Technical Service Bulletin

SUBJECT: Foot Switch Elimination for hydraulic brake light truck applications

Products Affected: New Installation kits for Ford E Series, Ford F Series chassis as well as Chevrolet G4500

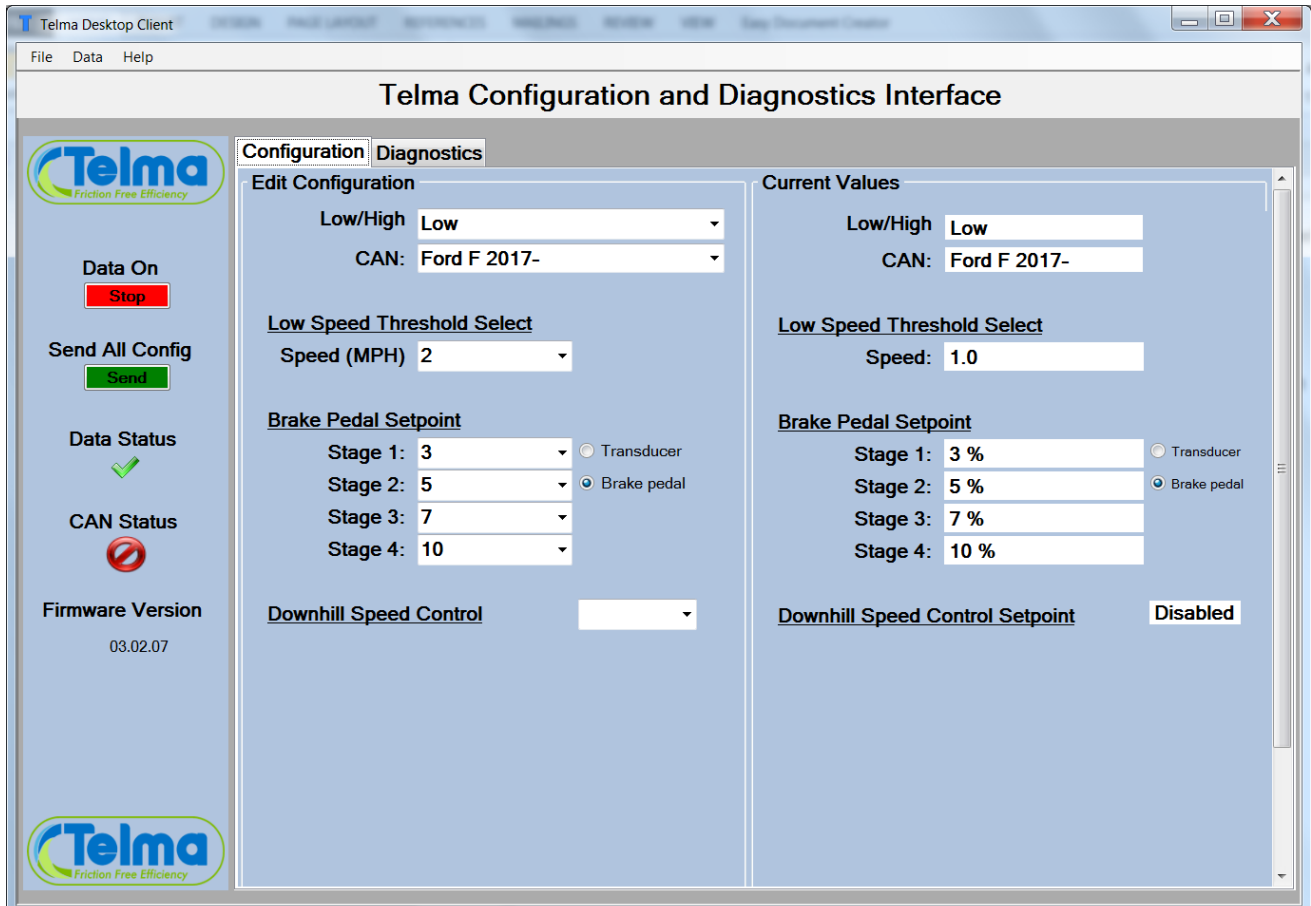
We are very happy to announce that it will no longer be necessary to install the rotary switch and bracket for Telma foot control on light truck chassis including Ford E Series, Ford F Series, and Chevrolet G4500 chassis.

Driver input for brake pedal position will now be obtained from the brake pedal position message broadcast on the CANBus.

Below is a screen shot of the updated Telma Desktop Client 03.02.07 and firmware version 03.02.07.
